Model: Cor-C1 / Cor-C1_SOP	Date: 05-Sep-14	No.: RD197001e
-----------------------------------	-----------------	----------------

Subject: Firmware Release Note: Engine		Prepared by: T. Tachibana	
From: 2nd Tech Service Sect., MFP/Printer Tech Service Dept.			
Classification:	<input type="checkbox"/> Troubleshooting	<input type="checkbox"/> Part information	<input type="checkbox"/> Action required
	<input type="checkbox"/> Mechanical	<input type="checkbox"/> Electrical	<input type="checkbox"/> Service manual revision
	<input type="checkbox"/> Paper path	<input type="checkbox"/> Transmit/receive	<input type="checkbox"/> Retrofit information
	<input type="checkbox"/> Product Safety	<input checked="" type="checkbox"/> Other (Firmware)	<input checked="" type="checkbox"/> Tier 2

This RTB has been issued to announce the firmware release information for the **Engine**.

U006_S001_S001_S005
SEAL:DEVELOPMENT:ASS'Y

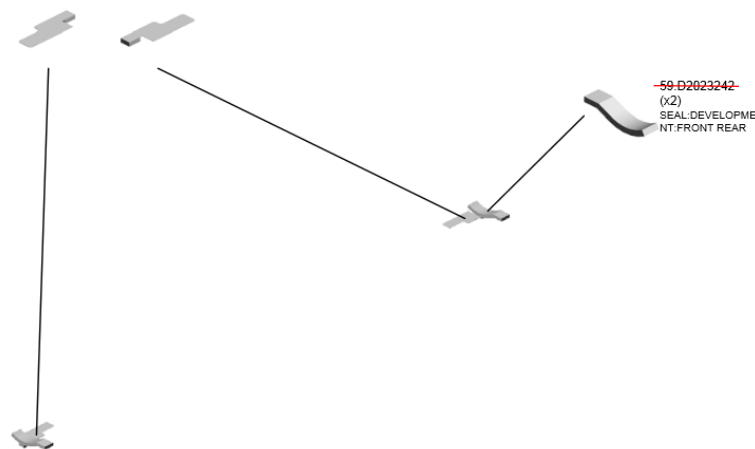
~~58-D2023225~~
SEAL:CASE ENTRANCE SEAL:REAR

~~57-D2023224~~
SEAL:CASE ENTRANCE SEAL:FRONT

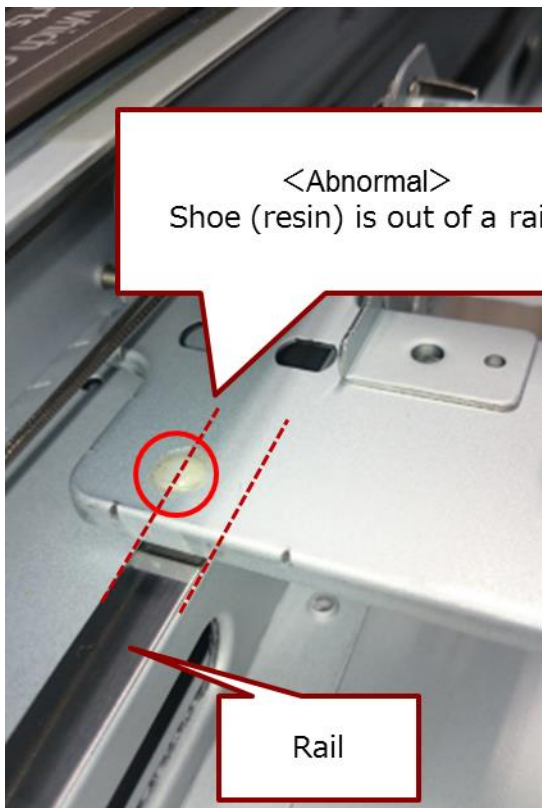
- SC121 (HP error) at installation.

The shoe (resin part circled in red) on the second scanner carriage disengages from the rail, due to shock and/or shaking during machine transport.

Pic. 1-1

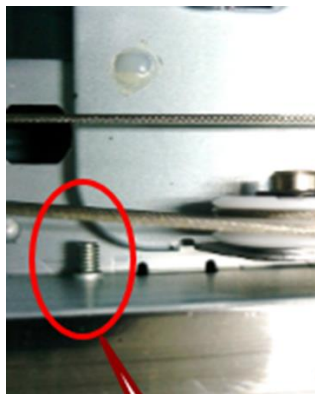
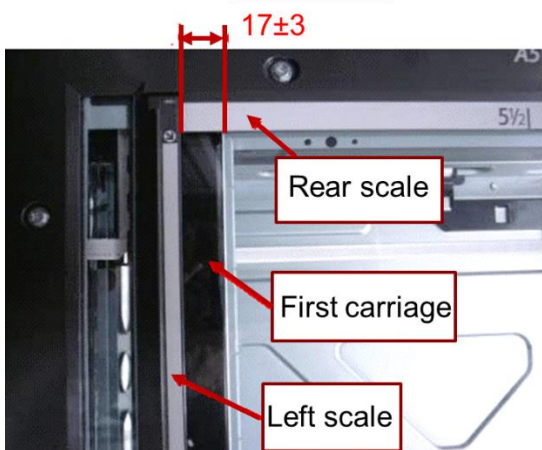
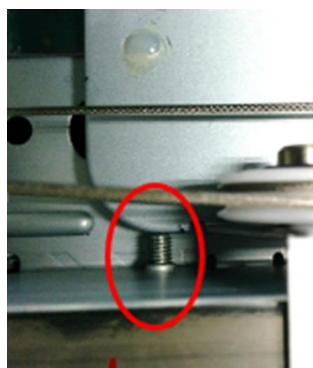
Before shipment, the first carriage will be moved to the new position shown below (the distance from the left scale to the edge of the carriage was decreased from 53 +/-3mm to 17 +/-3mm).

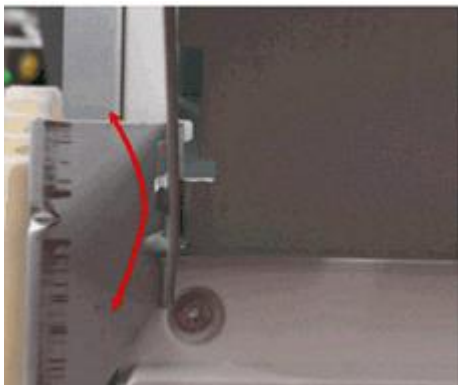
SC721 (Tray Lift Motor Error) occurs on the SR3140/SR3150 finisher.

There is a difference in level on the frame of the side plate tray. If the screw is tightened too tightly, the side plate may deform.
